Access Compliance Report

Public Rights-of-Way

(Curb Ramps)

Intersection ID: 45784	Main Street: CRABAPPLE_TREE_LN	Cross Street: LONG_HILL_DR	Location:	N
ADA ID: F2D485F32A9E	Ramp Type: Perp	Initial Pass/Fail: Fail	Overall Compliance: No	Severity Score: 12.5
Codes/Mitigation Info/Possible Solution		Field Measurements/Component Compliance

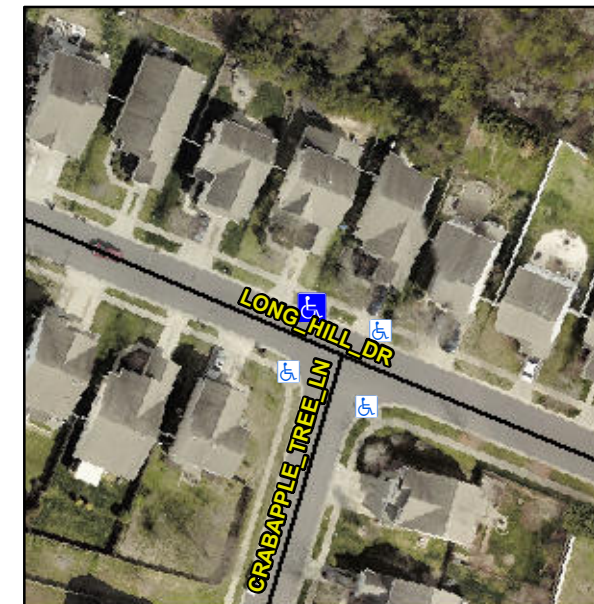
PROW/ADA:

Not Found, R304.2.2

Compliance	Description	Data	Compliance	Description	Data
N/A	Ramp Length (in)	72.0	No	Ramp Slope (%)	8.4
Yes	Ramp Width (in)	48.0	Yes	Ramp XSlope (%)	0.6
N/A	Flare Type LT	N/A	N/A	Flare Type RT	N/A
N/A	Flare Slope LT (%)	N/A	N/A	Flare Slope RT (%)	N/A
N/A	Flare Traversable LT?	N/A	N/A	Flare Traversable RT?	N/A
N/A	Landing Length (in)	N/A	N/A	DWS Provided?	N/A
N/A	Landing Width (in)	N/A	N/A	DWS Contrast?	N/A
N/A	Landing Slope (%)	N/A	N/A	DWS Length (in)	N/A
N/A	Landing X Slope (%)	N/A	N/A	DWS Full Width?	N/A
N/A	Landing Curb? (Y/N)	N/A	N/A	DWS Offset (in)	N/A
N/A	Shared Landing?	N/A			
N/A	Gutter Ponding?	N/A	N/A	Gutter Slope (%)	N/A
N/A	Gutter Lip Ht (in)	N/A	N/A	Gutter X Slope (%)	N/A
N/A	Painted X Walk1?	No	N/A	Painted X Walk2?	N/A
	X Walk 1 Direction	To SW		X Walk 2 Direction	N/A
N/A	X Walk 1 Width (in)	N/A	N/A	X Walk 2 Width (in)	N/A
	X Walk 1 Slope (%)	1.4		X Walk 2 Slope (%)	N/A
	X Walk 1 X Slope (%)	0.8		X Walk 2 X Slope (%)	N/A

Possible Solutions:

Remove & Replace Entire Ramp.
